From: "Hamer, Mike" <mhamer@entergy.com>
To: "Jonathan Rowley" <JGR@nrc.gov>
Date: Thu, Sep 7, 2006 12:00 PM
Subject: Vernon Hydro Station Safety Reports

**OPERATION REPORT
FEDERAL ENERGY REGULATORY COMMISSION
New York Regional Office**

Licensee: USGen New England, Inc. (USGen) Project No.: 1904-VT/NH
NATDAM No.: NH00097
Project Name: Vernon
Location: Connecticut River Windham/Cheshire VT/NH
(Waterway or reservation) (County) (State)
License issued: June 25, 1979 Expires: April 30, 2018 Type: MON
Date of last amendment: May 8, 2002 (Order Granting Extension of Time Under Article 301)
Inspected by: Liza Vélez and Michael Monahan Date: June 24, 2002
Parts of project inspected: Powerhouse, dam and fishway
Weather: Sunny; high 80's
Accompanied by: Bruce Davin, Director of Hydro operation; Justin Donaghy, Hydro engineer; Earl
Brissele, Maintenance Planner; John Ragonese, FERC License Manager.

Photo No. 12 - A typical Tainter Gate. This is Gate No. 2 being operated using power from Emergency Generator. Some rust spots were noted. The Licensee's representative stated the rust spots will be painted during the 2003 maintenance season.

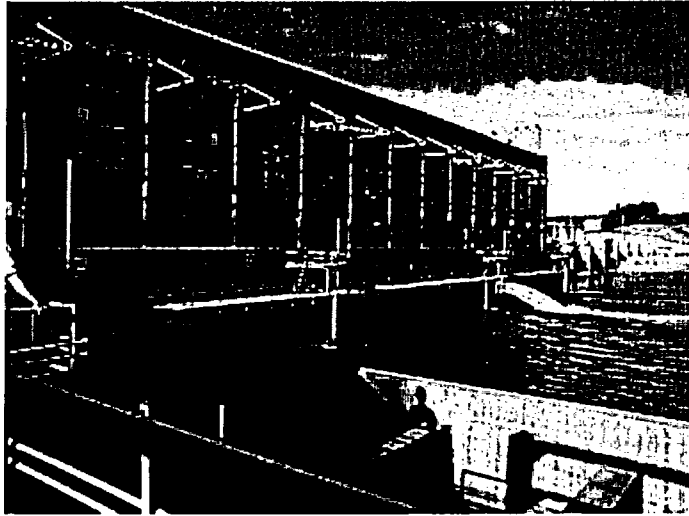
No problems occurred during the gate operation. An automatic Emergency Generator test is performed once per month. At the time of the inspection, all gates were reported to be operational. They appeared to be structurally sound. Rust spots were observed on the tainter gate that will be painted during the 2003 maintenance season.
